**CONGRUENT SOFTWARE, INC.**  
**3998 Whittle Avenue**  
**Oakland, CA 94602**  
**(510) 531-5472**  
**(510) 531-2942 FAX**

FROM: Peter Johansson  
 TO: T10 SBP-2 *ad hoc* Working Group  
 DATE: September 16, 1997  
 RE: Proposed SBP-2 Annex for Security

**Figure X.1 – Set password ORB**

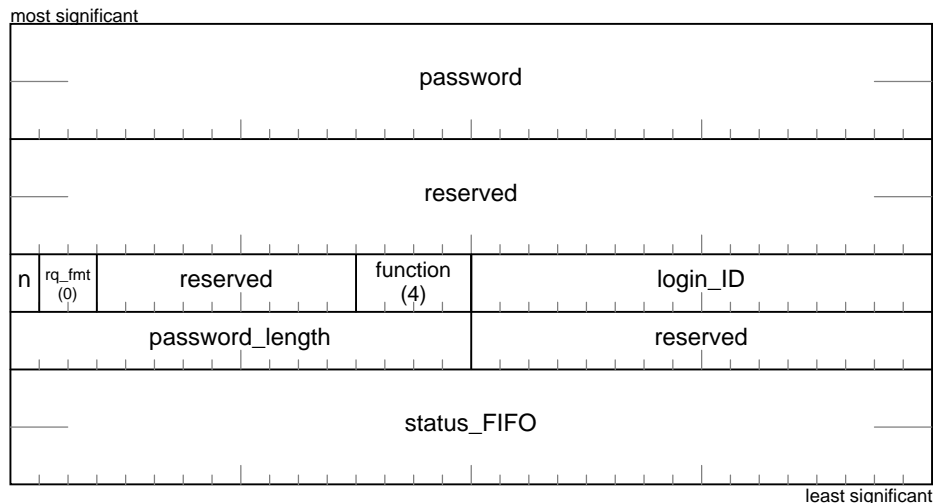
In order to change a target's current password, an initiator may use a management ORB with the format shown below.

The *password* and *password\_length* fields specify the new value for the current password. If *password\_length* is zero, the *password* field contains immediate data. When *password\_length* is nonzero, the *password* field shall conform to the format for address pointers specified by Figure 11 and shall specify the address of a buffer. The maximum value of *password\_length* shall be 28. The buffer shall be in the same node as the initiator and shall be accessible to a Serial Bus block read request with a data transfer length less than or equal to *password\_length*.

The *notify* bit and the *rq\_fmt* and the *function* fields are as previously defined for management ORB formats.

The *login\_ID* field shall specify a login ID value obtained as the result of a successful login.

The *status\_FIFO* field shall specify an address allocated for the return of status for the SET PASSWORD request, only. The contents of this field shall not update the status FIFO address established by the successful login that returned *login\_ID*.

If *login\_ID* specifies a valid current login for the initiator that signaled the SET PASSWORD request to the target's MANAGEMENT\_AGENT register, the target shall update the current password to the new value specified by the set password request. The target shall not return completion status for the request unless either the request is rejected or the new password has been successfully stored such that it will not be affected by any subsequent power reset, bus reset or command reset.
